dsPIC33FJ06GS101/X02 and dsPIC33FJ16GSX02/X04 Family Silicon Errata and Data Sheet Clarification

The dsPIC33FJ06GS101/X02 and dsPIC33FJ16GSX02/X04 family devices that you have received conform functionally to the current Device Data Sheet (DS70000318G), except for the anomalies described in this document.

FIGURE 1: TIMING DIAGRAMS FOR CENTER-ALIGNED AND EDGE-ALIGNED MODES

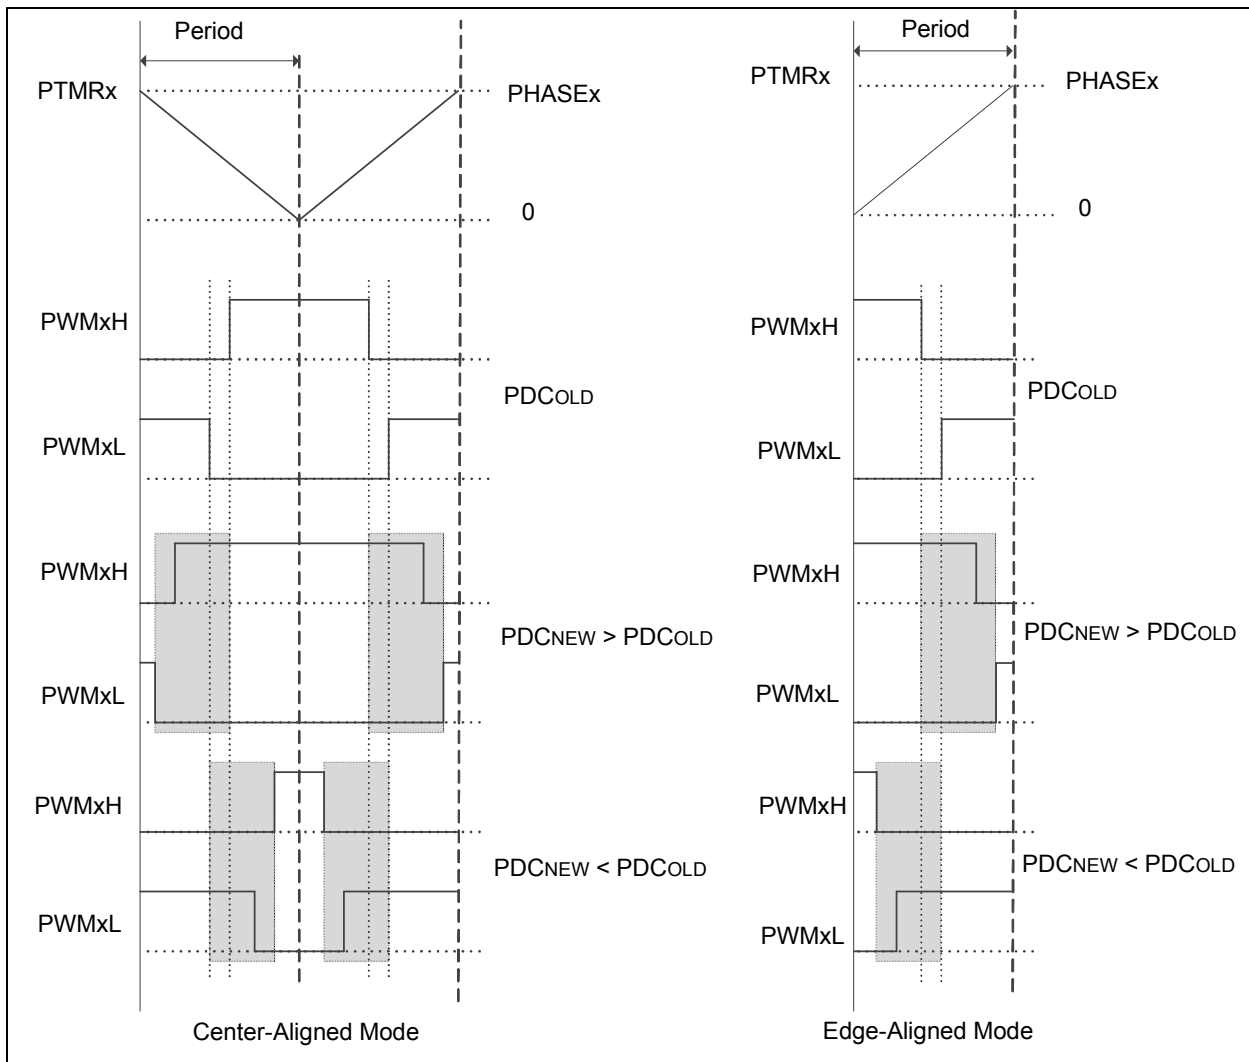
In [Figure 1](#) (following page), if the duty cycle write occurred in the shaded box, then PWMxH and PWMxL will make an immediate transition without dead time.

FIGURE 2: ISSUE EXAMPLE FOR REDUNDANT OUTPUT MODE

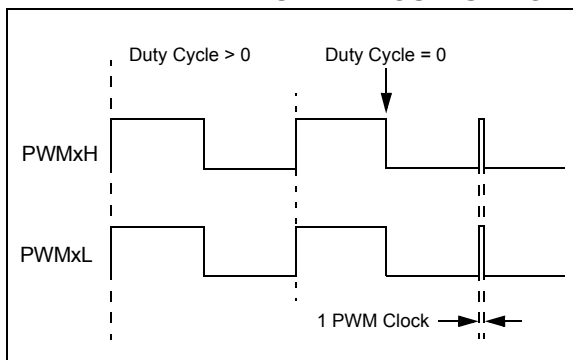
In Redundant Output mode (IOCONx[11:10] = 01) and Push-Pull Output mode (IOCONx[11:10] = 10), with the Immediate Update disabled (PWMCONx[0] = 0), when the Duty Cycle register is updated from a non-zero value to zero, a glitch pulse of a width equal to 1 PWM clock will appear at the next PWM period boundary, as shown in Figure 2 (for the Redundant Output mode). The Duty Cycle register refers to the PDCx register if PWMCONx[8] = 0 or the MDC register if PWMCONx[8] = 1.

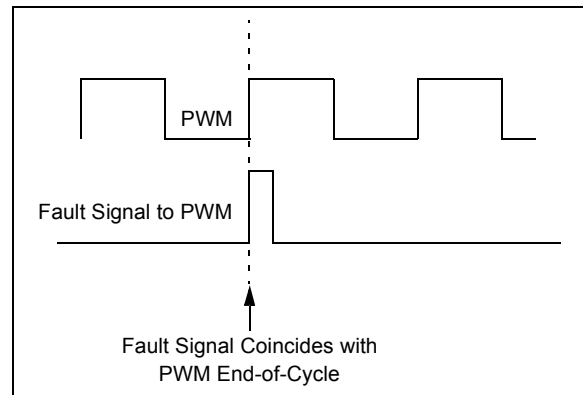
When the PWM module is operated in Complementary, Redundant, Push-Pull or True Independent Output modes and the PWM Fault/Current-Limit Fault are configured to provide a Fault event to the PWM, under certain conditions where the Fault event active edge happens to coincide with the PWM End-of-Cycle (EOC) event, the PWM fails to recognize the Fault event.
